Rezoning Application: PD 23-0993
Zoning Hearing Master Date: February 20, 2024
BOCC Land Use Meeting Date: April 9, 2024

AGENCY REVIEW COMMENT SHEET

REVIEWER: James Ratliff, AICP, PTP, Principal Planner

2.5 Option 2 Proposed Site Plan (partial provided below for size and orientation purposes. See Section 8.0 for full site plan)

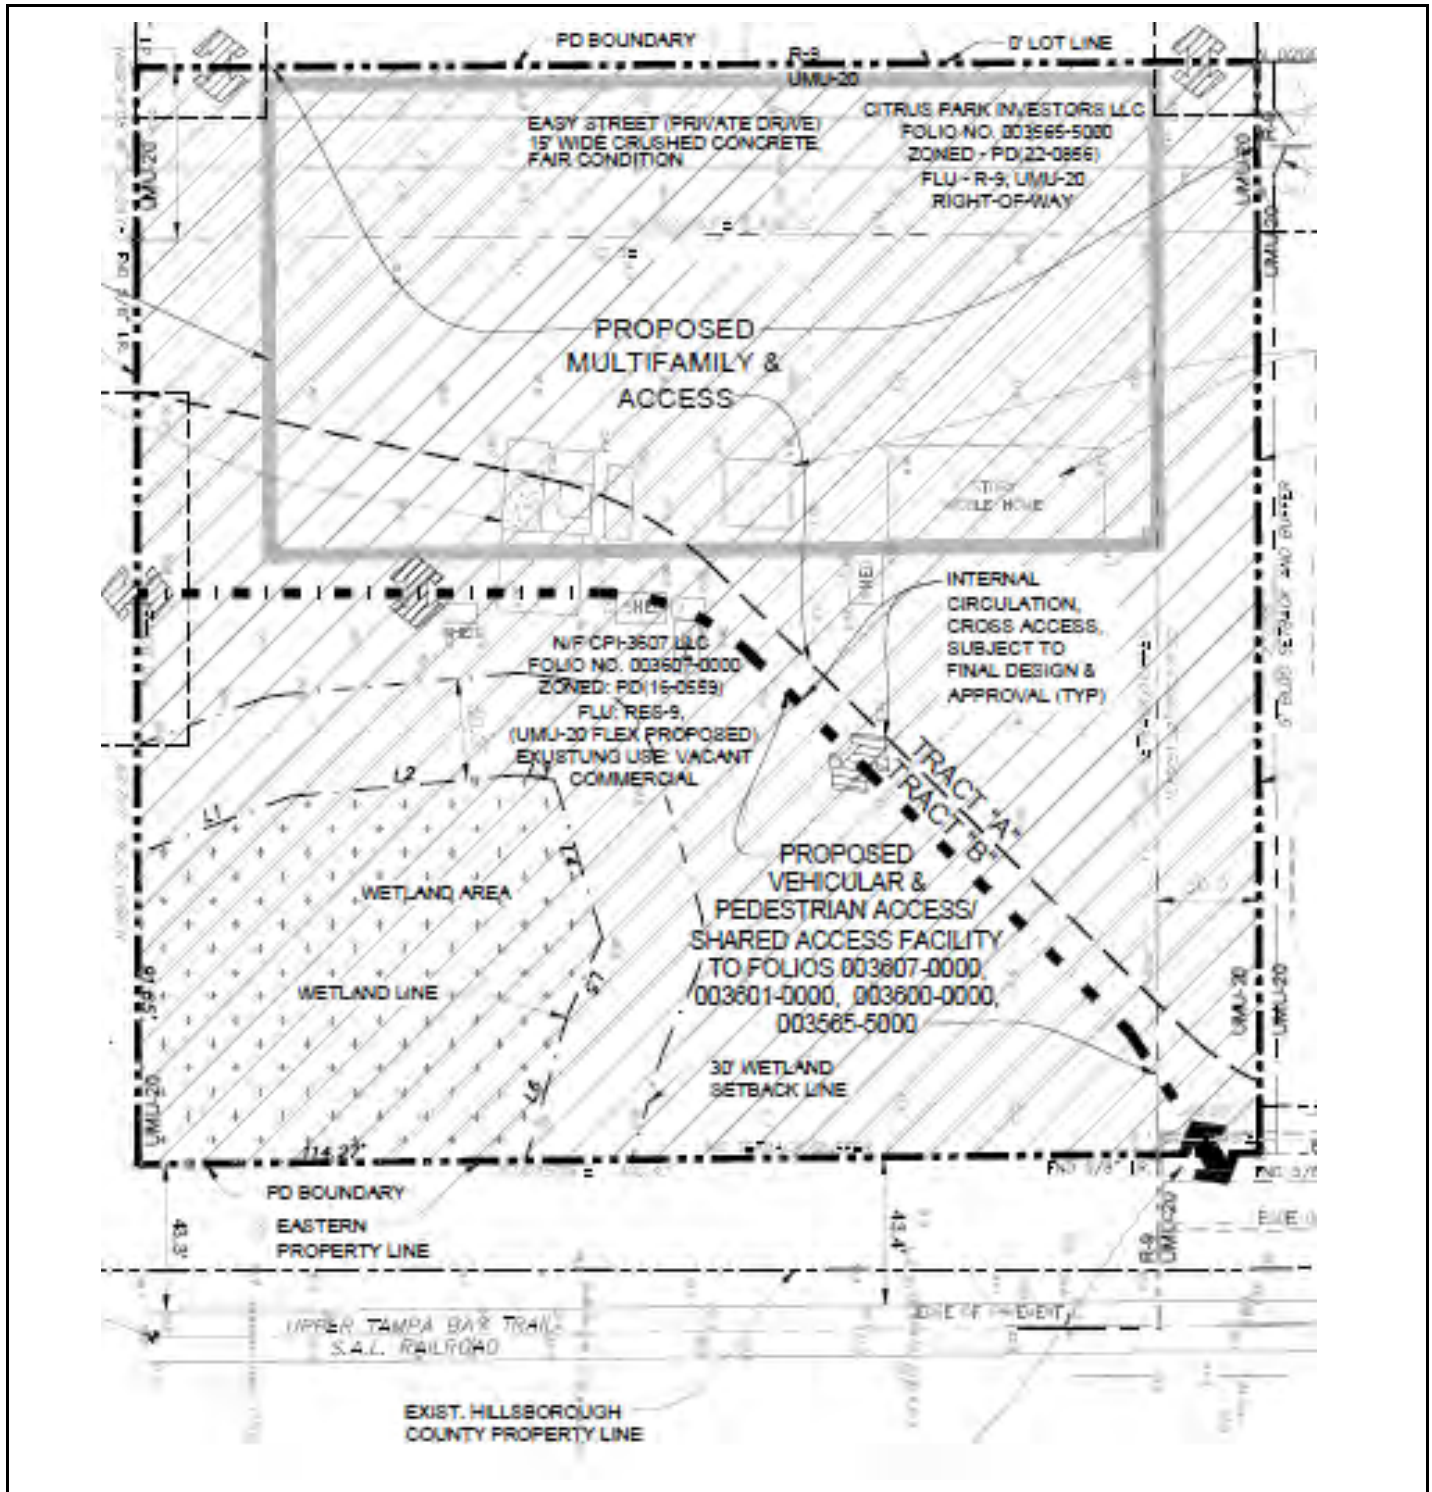
Prior to PD Site Plan Certification, the developer shall revise the PD Option 2 site plan to:

1. Replace the proposed square footage of 106,609 SF with the existing entitlement of 81,798 SF in the "Site Data" table.
2. Modify the "Site Data" data table to add a line underneath the Maximum Density Line which reads as follows: "Proposed Density: None*". Add a Note underneath the table reading as follows "**Although no vertical entitlements are proposed within this PD, blending of entitlements are permitted subject to restrictions – see conditions of approval."

3. Replace Site Note 9 with a note stating "All existing easements on-site and within 150 feet of the site are as shown. Regardless of any easement which may exist, no access other than those specified in the zoning conditions shall be permitted."

4. Replace Site Note 25 with a note stating "Proposed vehicular access connections shall be as shown on the PD site plan. All other access connections shall be closed/discontinued."

6. Add to labels on applicable adjacent properties as follows "Pending Modification: PD 23-0994" and "Pending Modification: PD 24-0031".

8. Change all existing arrows on the plan to Black Arrows. Add a new arrow white/cross-hatched arrow to Easy St. Modify the legend for the white/cross-hatched arrow to read "Proposed Limited Purpose Vehicular Access – See Conditions of Approval".
9. Delete the label stating, "Existing Connection to be Relocated". *[Staff notes this deletion will be handled in the 23-0994 PD request.]*

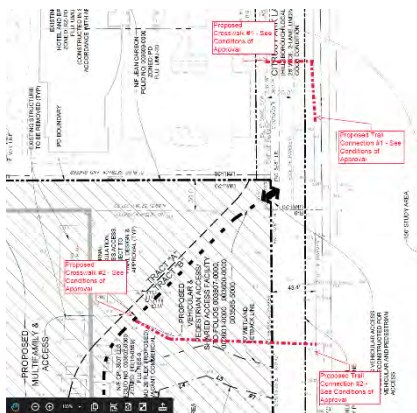
7. Add location of required ADA compliant trail connections and crosswalks as shown left. Label the two connections as follows: "Proposed Crosswalk #1 – See Conditions of Approval", "Proposed Trail Connection #1 – See Conditions of Approval", "Proposed Crosswalk #2 – See Conditions of Approval", and "Proposed Trail Connection #2 – See Conditions of Approval".

TRANSPORTATION NOTE:

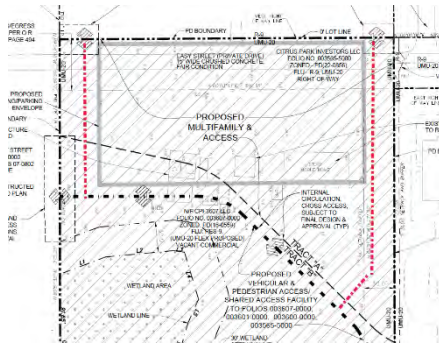
- 10. Delete the Transportation Note and language shown left (i.e. dealing with vested trips) from this plan option sheet.

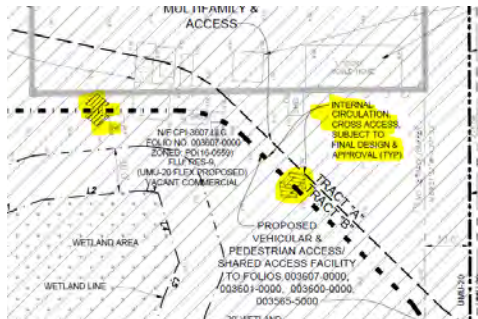
- 11. "Change the label within the legend stating, "Internal Vehicular and Pedestrian Circulation" to instead state "Proposed Citrus Park Ln. Extension".

- 12. Add a new line type and label within the legend called "Conceptual Vehicular and Pedestrian Circulation". Add linework corresponding to the new line type in the locations shown left. [Staff notes that additional internal circulation can be shown if desired, but at a minimum, you must show the arrows to adjacent PDs connecting to the Citrus Park Ln. Extension line.]

- 13. Delete the two yellow arrows and the label highlighted in yellow to the left. [Staff notes that there may be more/different connections than just those shown. Since this is occurring within the PD, and on a lower volume section of the roadway, they need not be shown (and this will maximize flexibility at the time of plat/site/construction plan review. Staff notes that access to the Citrus Park Ln. extension will be subject to compliance with Sec. 6.04.07 access spacing standards and other applicable regulations at the time of plat/site/construction plan review.)]

THE PROJECT IS UNDER THE SAME OWNERSHIP AS THE PROJECT KNOWN AS CITRUS PARK CROSSINGS AND SHALL UTILIZE THE REMAINING TRIPS VESTED IN THE PROJECT'S CONCURRENCY APPROVAL AND COMPLETED OFFSITE IMPROVEMENTS.

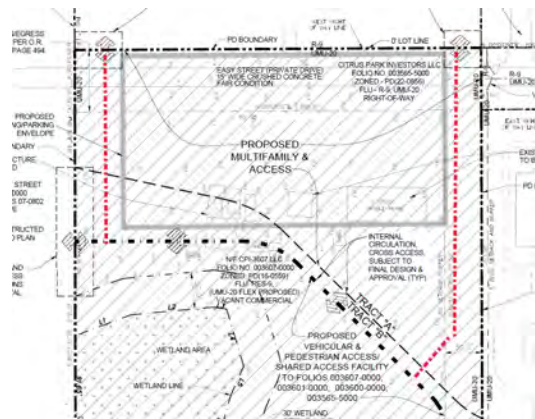
- Change all existing arrows on the plan to Black Arrows. Add a new arrow white/cross-hatched arrow to Easy St. Modify the legend for the white/cross-hatched arrow to read “Proposed Limited Purpose Vehicular Access – See Conditions of Approval”.
- Delete the label stating “Existing Connection to be Relocated”. [Staff notes this deletion will be handled in the 23-0994 PD request.]
- Delete the Transportation Note and language show below (i.e. dealing with vested trips) from this plan option sheet.

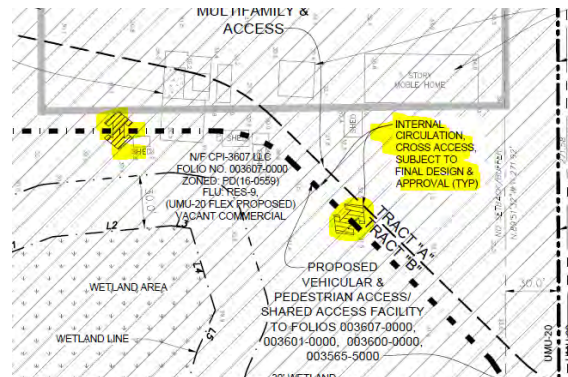
- “Change the label within the legend stating “Internal Vehicular and Pedestrian Circulation” to instead state “Proposed Citrus Park Ln. Extension”.
- Add a new line type and label within the legend called “Conceptual Vehicular and Pedestrian Circulation”. Add linework corresponding to the new line type in the locations shown below. *[Staff notes that additional internal circulation can be shown if desired, but at a minimum you must show the arrows to adjacent PDs connecting to the Citrus Park Ln. Extension line.]*

- Delete the two yellow arrows and the label highlighted in yellow below. *[Staff notes that there may be more/different connections that just those shown. Since this is occurring within the PD, and on a lower volume section of the roadway, they need not be shown (and this will maximize flexibility at the time of plat/site/construction plan review. Staff notes that access to the Citrus Park Ln. Extension will be subject to compliance with Sec. 6.04.07 access spacing standards and other applicable regulations at the time of plat/site/construction plan review.)]*

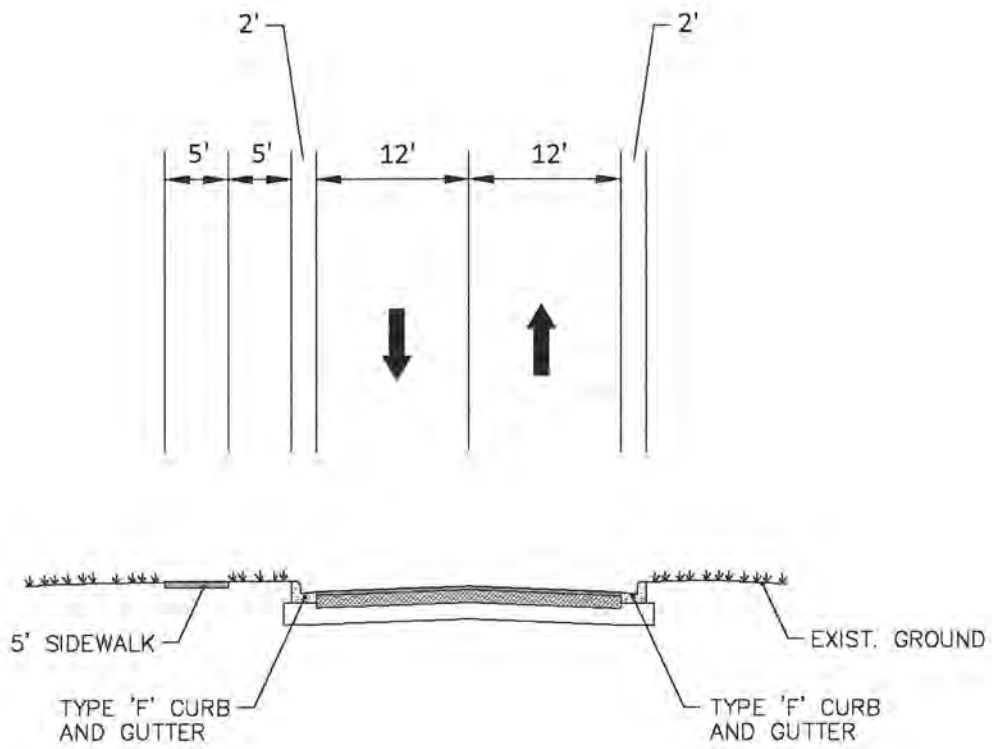
Approved with Conditions:

- 1) Subject to the clarifications contained on other pages herein this document.
- 2) This Design Exception shall apply to the following projects and entitlements:
23-0993 (Option 2): No Entitlements
23-0994: 312 Multifamily Apartments
24-0031: 230 Multifamily Townhomes
- 3) Clarification that Upper Tampa Bay Trail connection shall include a crosswalk across Citrus Park Ln., as specified in the zoning conditions.
